RE: Nash Unit #053 SWD API NO. 30-015-39400 Sec. 13, T23S, R29E Unit Ltr. H

XTO Energy, Inc. would like to request an amendment on the Nash Unit #053 SWD as addressed in our telephone conservation on the morning of March 6, 2012. Along with this request we are sending you a current wellbore diagram, formation tops and the geologist explanation of the Devonian formations productivity at the permitted depth since it came in higher than permitted when the well was completed.

NASH UNIT #053 SWD WELLBORE DIAGRAM

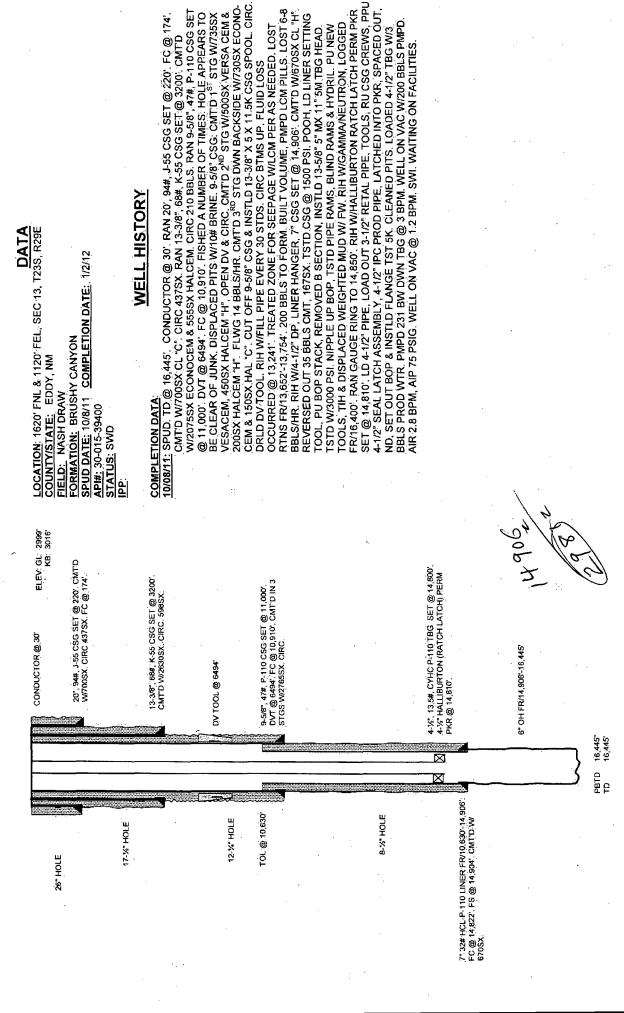
The C-103 form stated that we were out of compliance with the packer depth being set at 14,810° which is 264° above the permitted interval of 15,074 - 16,510. Thanks for you help with this matter.

The top of Devonian did come in higher than expected, we estimated it to come in at 15,074 ft MD, when in fact it was actually at 14, 903 ft MD. This discrepancy is due mostly to the lack of nearby deeper Devonian penetrations. In regards to the Devonian being productive, the nearest offset Devonian historical producer (no longer in current production) that I was able to find, was more than 8 miles from the subject well. Also, the mudlog from the Nash Unit 53 SWD displayed no oil shows and very low total gas, averaging ~10 units, on the mudlog.

The previous permits require a copy of the logs and also a mudlog (over the Devonian) be sent to the Division for this API number 30-015-39400
